**FIELD SERVICE BULLETIN**

FSB Number: LVCCFSB2003-129  
Author: Tony Bryan  
Date: December 05, 2003  
Total No. of Pages: 4  
Subject: **GSM V300 Flip Assembly (C56-CLI Chassis Short)**  
Model Affected: V300  
Level of Repair: 3

Figure 2.0 - Rework Procedure

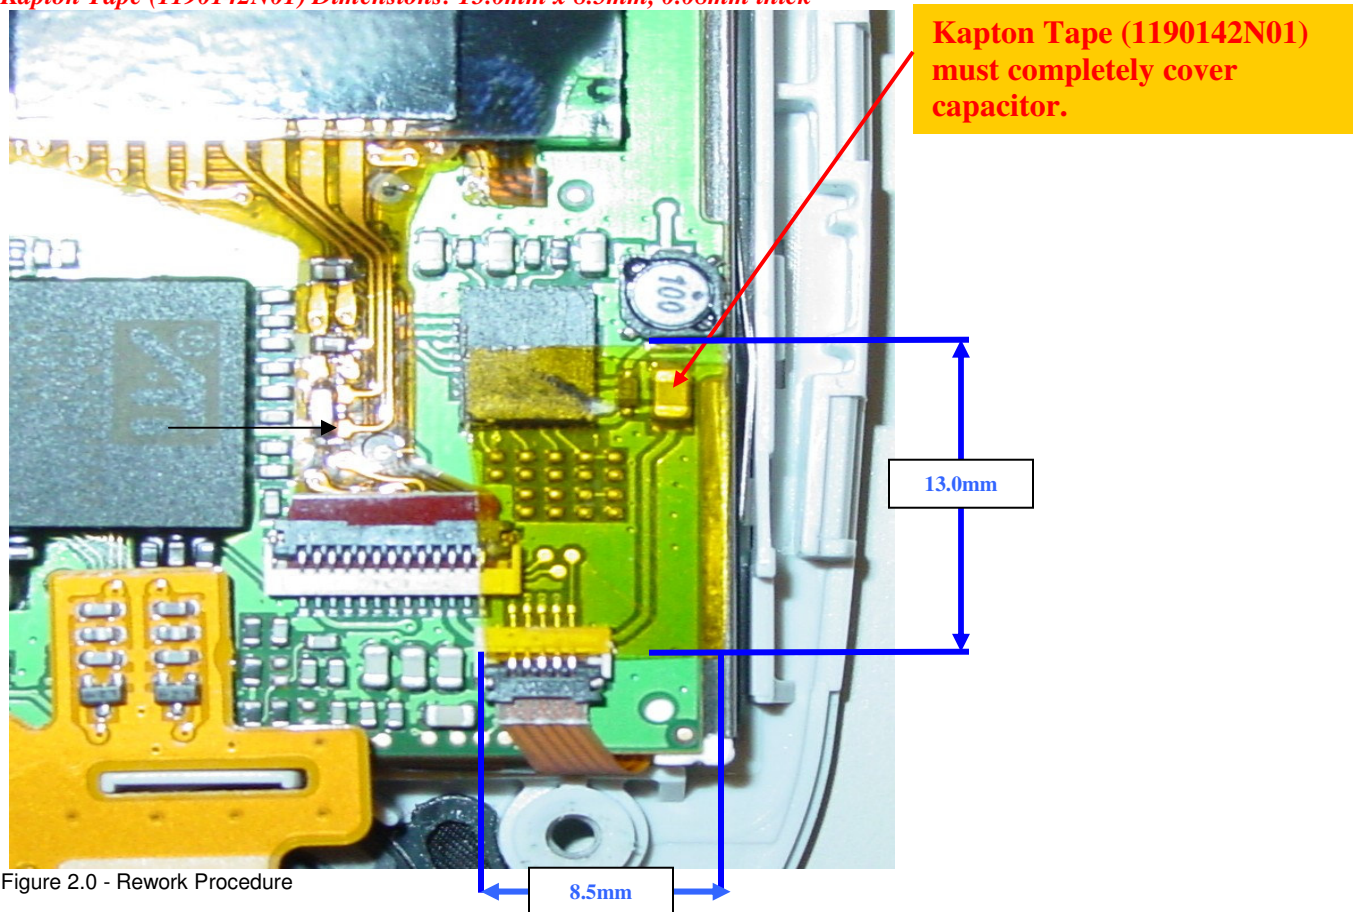
This issue was identified by the factories during initial production builds of V300. A rework procedure was developed and released, as of October 3<sup>rd</sup> 2003, to the suppliers to be implemented in 100% of all production flip assemblies. A total of 10,000 assembled V300 units were quarantined in the factories to have this rework. See detailed rework instructions below in Figure 2.0.

**Kapton Tape Rework Procedure**

*Kapton Tape (1190142N01) Dimensions: 13.0mm x 8.5mm, 0.08mm thick*

Figure 3.0 - Redesign of CLI Chassis

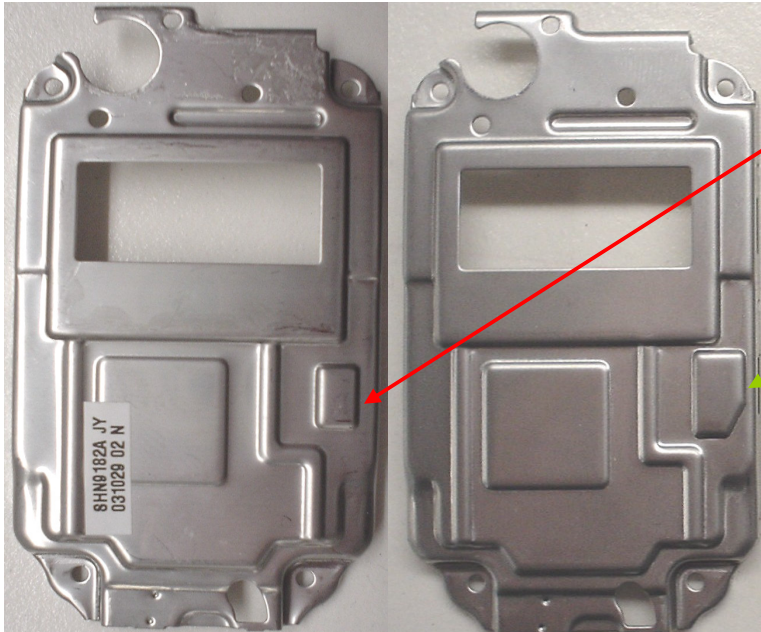
Redesign of CLI Chassis (0788807N01) Rev. E to allow additional clearance for C56. See Figure 3.0 below. Tooling for Rev. E chassis is in place at the suppliers and pilot builds have been completed of the Rev. E chassis as of 11/14/03. Production is scheduled to cut over to the Rev. E Chassis by the 1<sup>st</sup> week in January.

Current Rev. D Chassis

NEW Rev. E Chassis

**Capacitor interferes with chassis.**

**Additional clearance for capacitor added to chassis.**
